**Storey Time Learning Center and Aftercare
Site Plan Amendment
Planning Board Site Plan Review
July 20, 2021**

Re: Septic Capacity, 133 Middle Road Cumberland for proposed daycare

SUBSURFACE WASTEWATER DISPOSAL PLAN

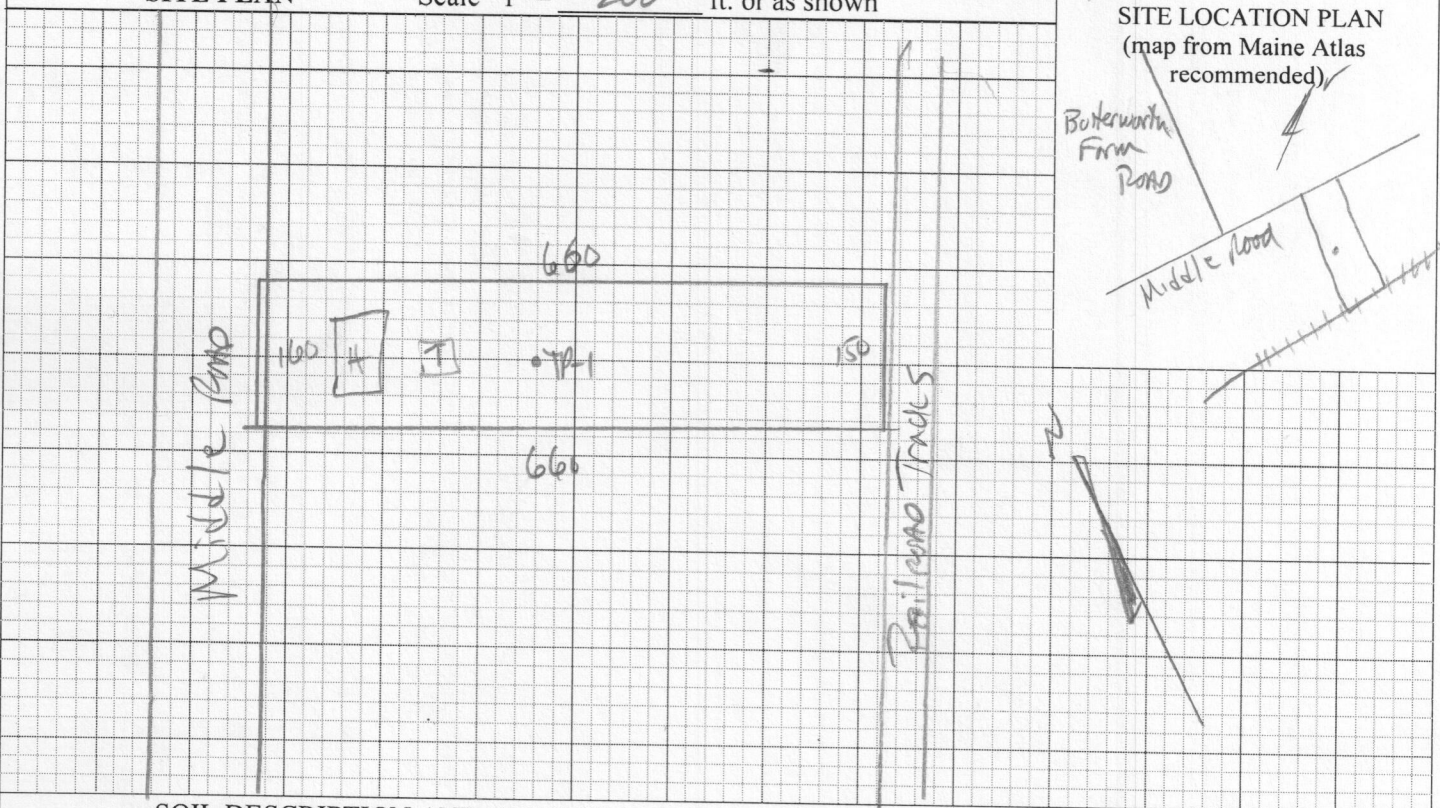
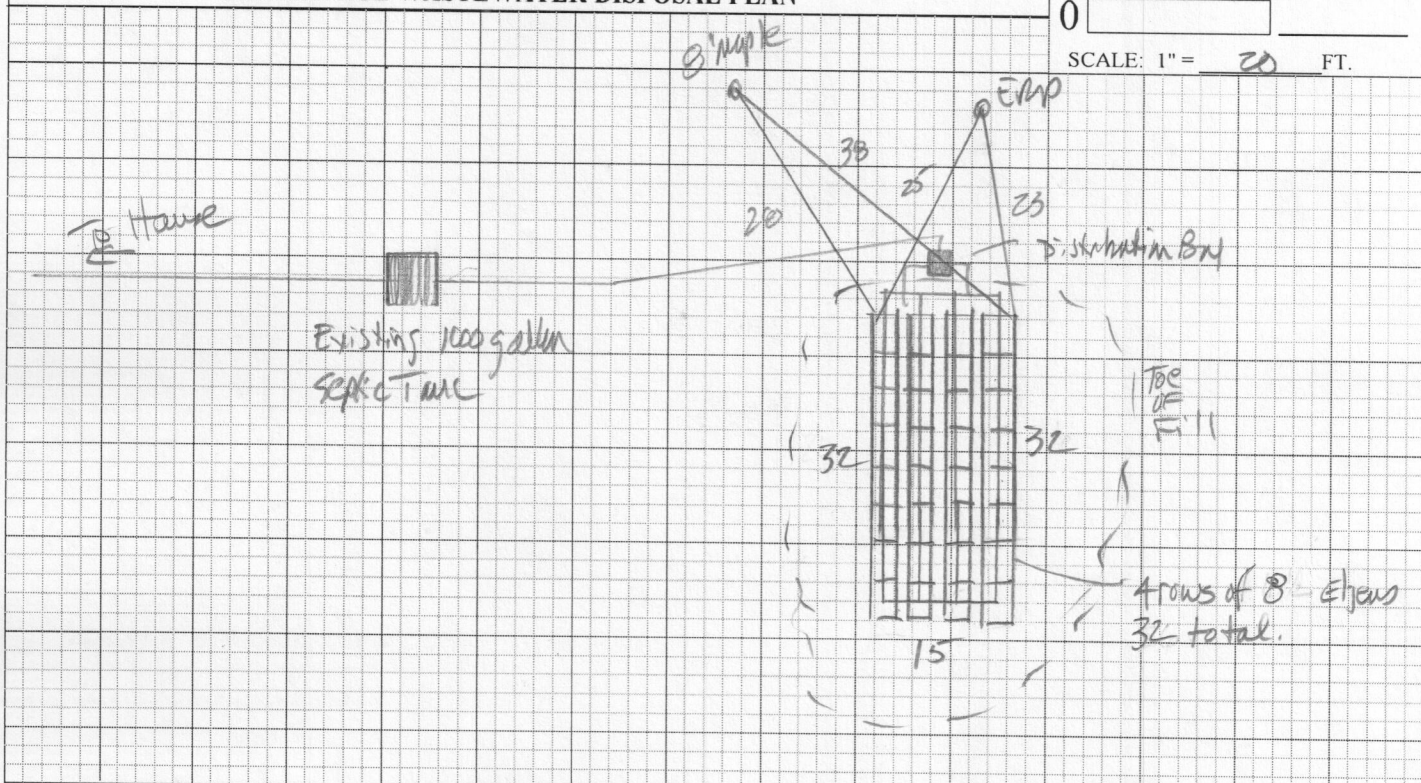
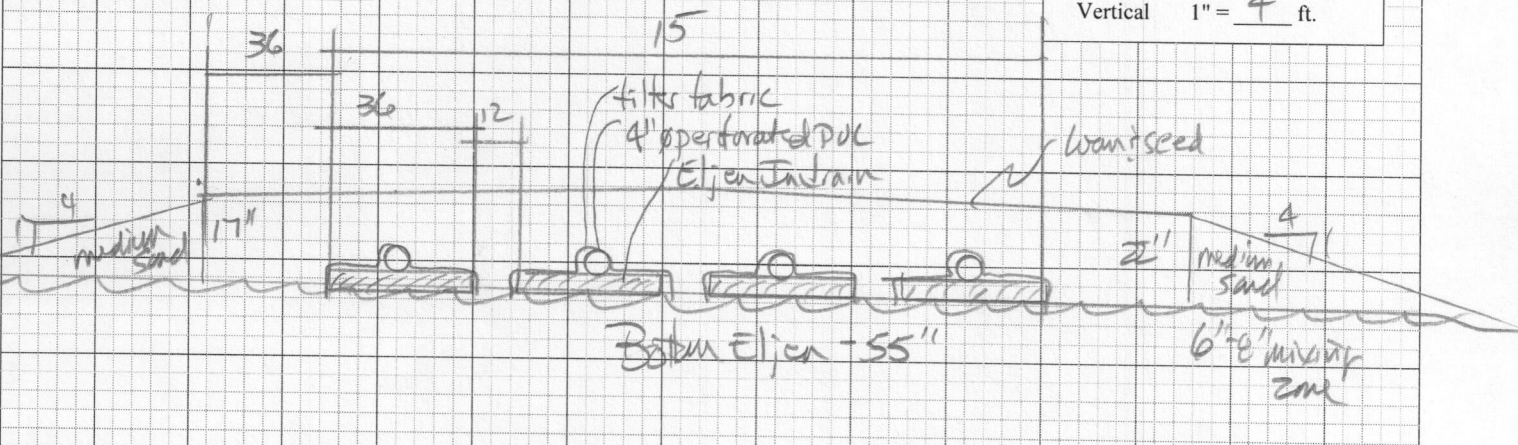
The applicant will need to provide evidence that the existing septic system, or an addition to that system, will accommodate an increased number of children beyond 30 (and staff, beyond 3) that the system is currently sized for. The Town Code Enforcement Officer be required to issue a plumbing permit for this.

As I understand, you now want to not serve meals to the children and increase the capacity of the daycare. Children at a daycare that does not serve meals are allocated 10 gallons per day. So, to stay within the design parameters of the existing septic system, you could increase the number of children to 30 and the number of staff is to remain at 3.
